REV.
C

AS3417™

BOLT, MACHINE, DOUBLE HEX,
EXTENDED WASHER HEAD, CLOSE TOL. SHANK,
UNS N07718, 185 KSI MIN, .1900-32 UNJF-3A
(STRESS RUPTURE RESISTANT)

FIGURE 1 - BOLT

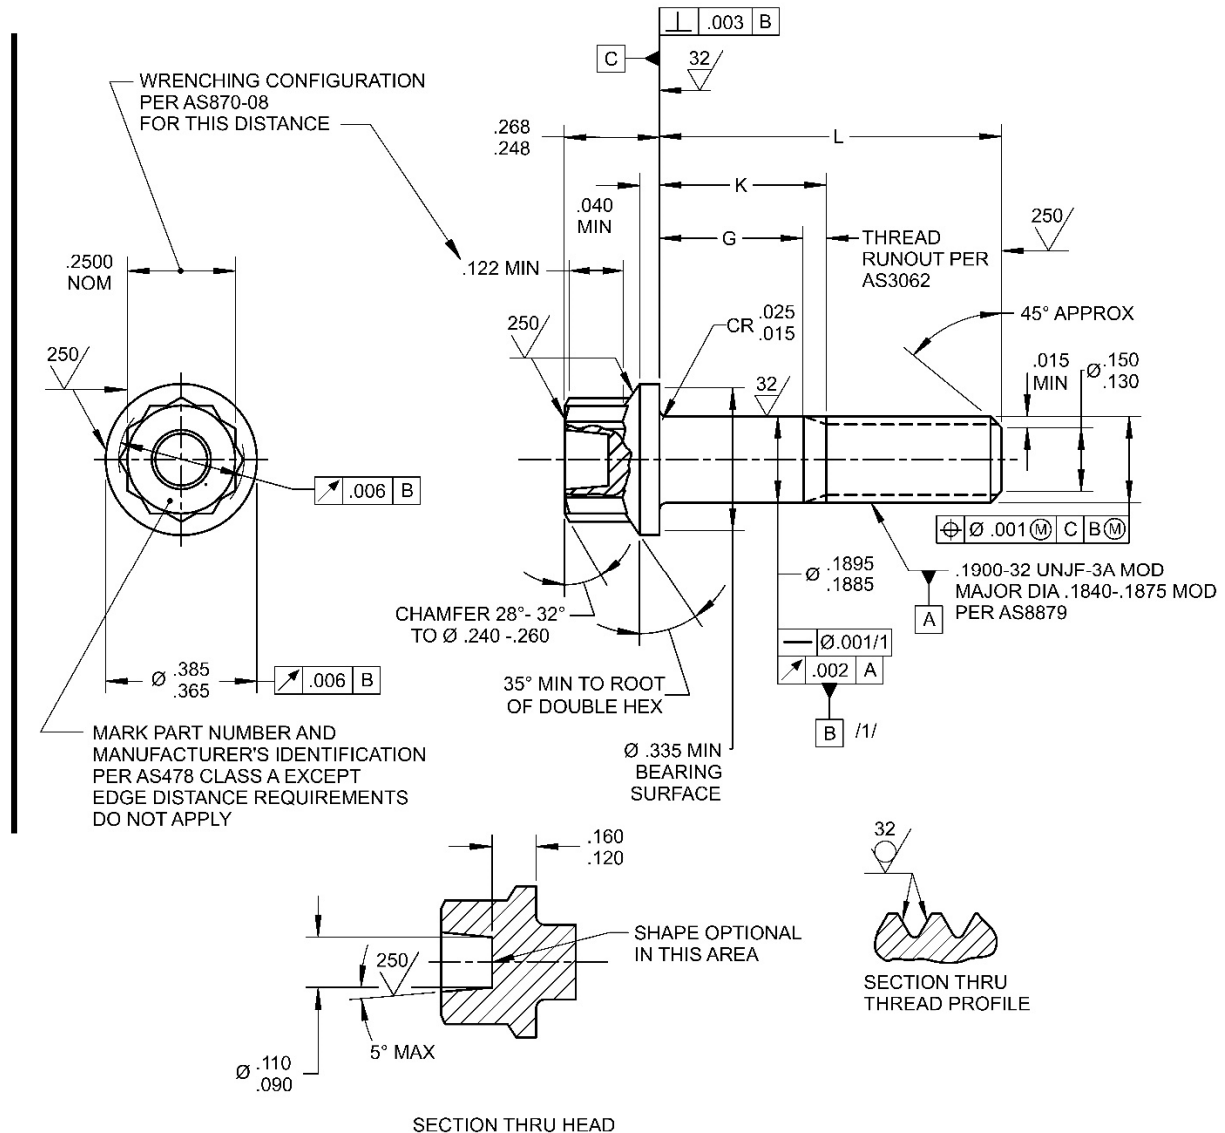
UPDATE TO ASME Y14.5-2018. UPDATE LEAD THREAD CHAMFER TO AS1132. REVISE POSITION FCF ON MAJ DIA TO INCLUDE NEW DATUM C PER AS1132. REVISE LIGHTENING HOLE CONFIGURATION TO AS1132. REVISE HEAD-TO-SHANK FILLET TO CR. NOTE 2 - ADD "COMPOSITION SIMILAR TO." GENERAL EDITORIAL UPDATES.
